U.S. NUCLEAR REGULATORY COMMISSION
FINAL SAFETY EVALUATION BY THE OFFICE OF NUCLEAR REACTOR REGULATION
FOR WESTINGHOUSE ELECTRIC COMPANY
TOPICAL REPORTS WCAP-17503-P/WCAP-17503-NP, REVISION 1,
“WESTINGHOUSE GENERIC SETPOINT CONTROL PROGRAM RECOMMENDATIONS,”
AND WCAP-17504-P/WCAP-17504-NP, REVISION 1,
“WESTINGHOUSE GENERIC SETPOINT METHODOLOGY”
PROJECT NO. 700

of these terms among one another is illustrated in Figure 3-1 of WCAP-17504-P/WCAP-17504-NP, Revision 1, reproduced below.

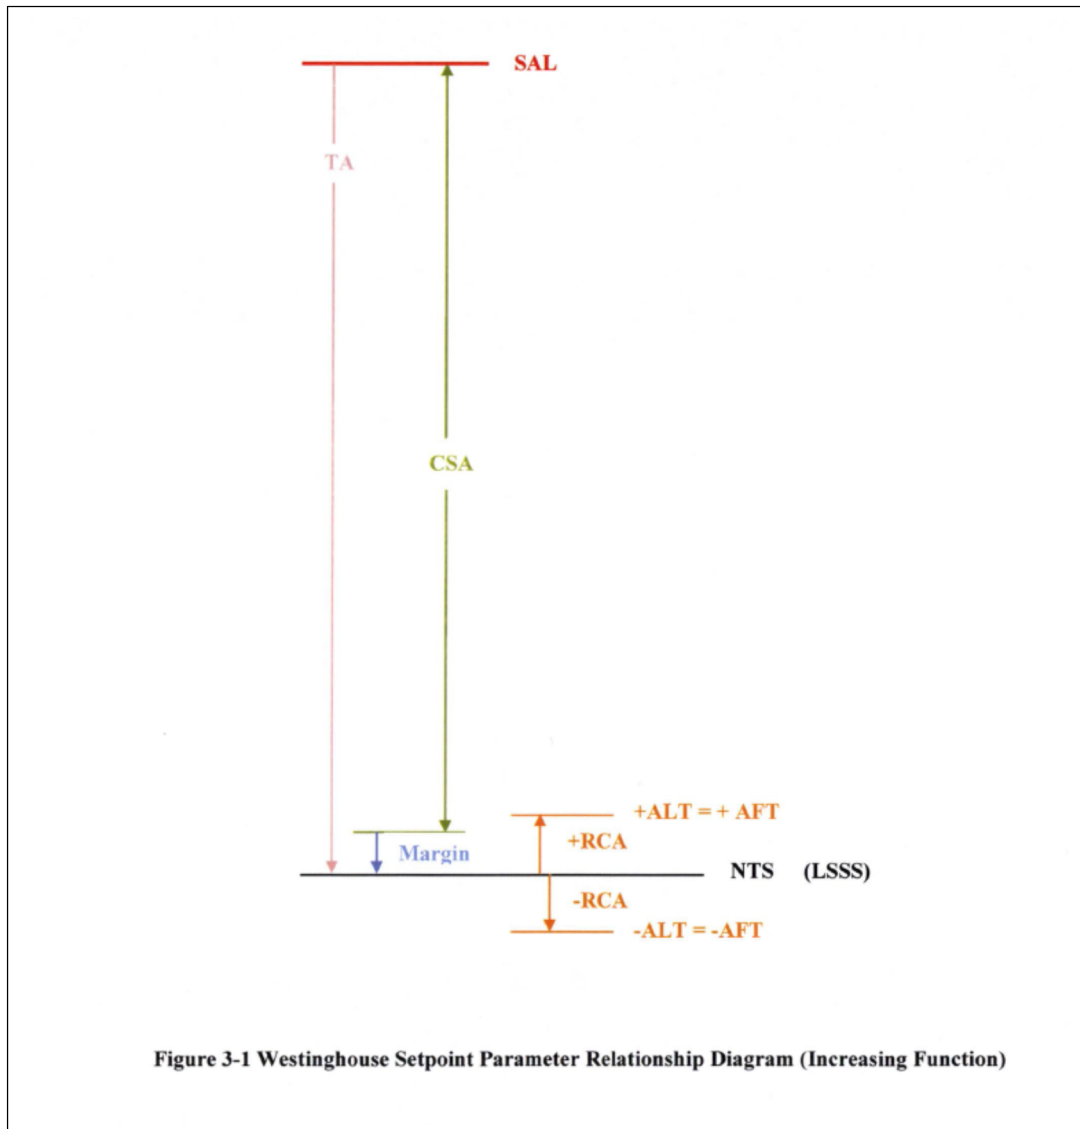
The NRC staff finds that this definition corresponds to staff's understanding of "Analytical Limit," as defined in the endorsed ISA 67.04 Standard—namely, "the value of a given process variable at which the safety analysis models the initiation of the instrument channel protective action." This is the parameter value considered in modeling and analysis of nuclear plant safety systems for design-basis accidents, transients, and anticipated operational occurrences, such that if the initiation of a protective function occurs at a value more conservative than this limit, the safety analyses conclusions will demonstrate successful prevention or mitigation.

The NRC staff finds that WCAP-17504-P/WCAP-17504-NP, Revision 1, adequately describes the important relationships among Safety Limit, Analytical Limit, Limiting Trip Setpoint, Allowable Value, Setpoint, Acceptable AFT Band, Acceptable ALT Band, and Setting Tolerance. Based on the discussion of terms and relationships presented in the WCAP-17504-P/WCAP-17504-NP, Revision 1, and the sample calculations, tables, and figures presented in WCAP-17504-P/WCAP-17504-NP, Revision 1, the NRC staff finds that the Westinghouse setpoint methodology demonstrates that the correct relationships between the SL, AL, NTSP, AFT, and ALT will be ensured, that the basis for the NTS is correct, and that the requirements of GDC 13 and 20 are met.

Therefore, the WSM described in the WCAP-17504-P/WCAP-17504-NP, Revision 1, uses double-sided evaluation acceptance criteria bands. Figure 3-1 (above) and the relationships described above illustrate how the operability of the instrument loop is evaluated. Exceeding the AFT in either high or low direction may indicate degraded performance and inability of the instrument channel to meet its intended function. Not being able to reset the setpoint to within the ALT at the conclusion of a channel calibration process also may indicate degraded performance and inability of the instrument channel to meet its intended function.
